ARKANSAS DEPARTMENT OF POLLUTION CONTROL AND ECOLOGY

MEMORANDUM

TO: Mike Hood, Technical Manager, Solid Waste Division *MAA*
FROM: Robert Lemmer, Geologist Supervisor, Solid Waste Division
DATE: January 6, 1997
SUBJECT: Preliminary Site Investigation, Conducted on November 7, 1996, for the Proposed Modification of the USA/Sunray Services Class 1 Landfill at Tontitown, Arkansas
CSN: 72-0144 Permit No.: P097

FIGURE 3

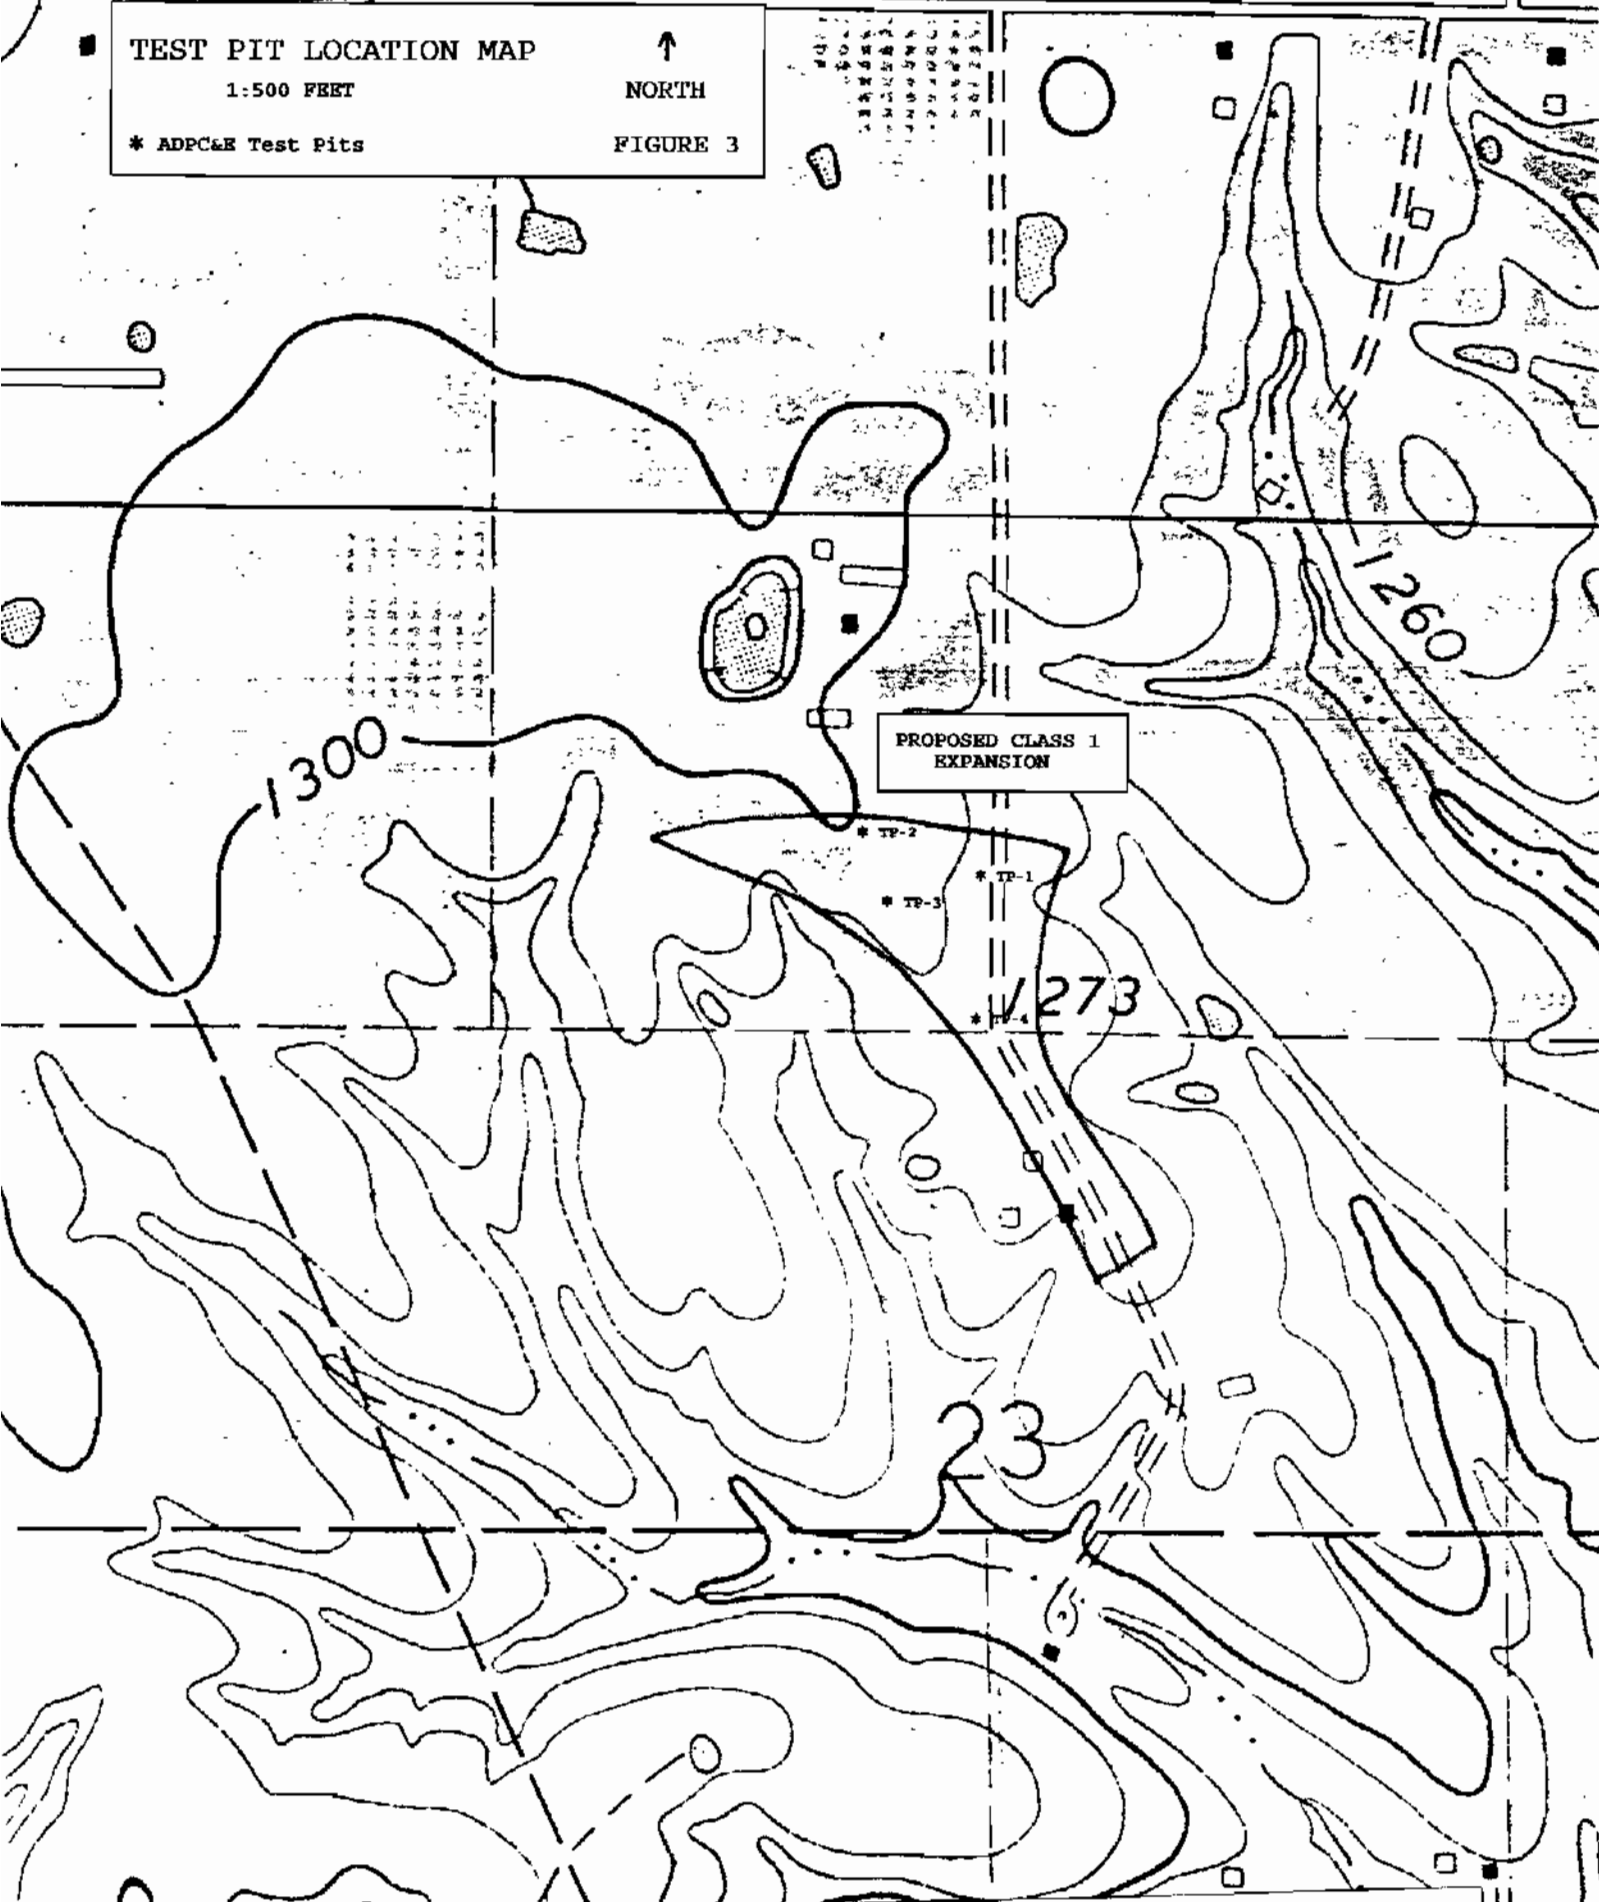
The test pits were generally about twelve (12) feet long and six (6) to eight (8) feet deep. All of the test pits were logged from the surface and on the proposed footprint. The logs of the test pits can be found at the end of this memorandum, and their locations can be seen on Figure 3. No test pits were excavated south of the facility's weigh scales because of truck activity to and from the active disposal areas of the facility.

10 75 TRENCH NO. TP-2

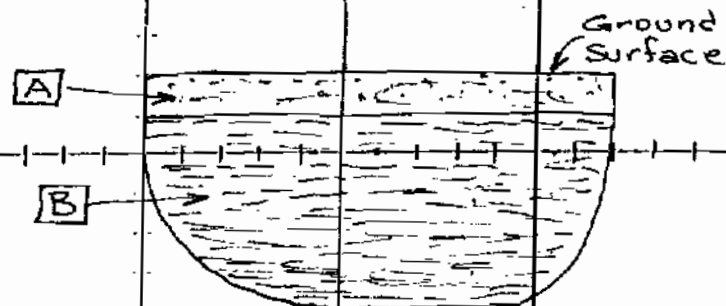
Section 22.425(b)(2) requires a minimum separation of 10 feet from the liner to bedrock high points (pinnacles). A possible pinnacle was encountered in TP-2 at a depth of six feet. The applicant should determine if any bedrock exists at a depth of less than ten feet anywhere on the site.
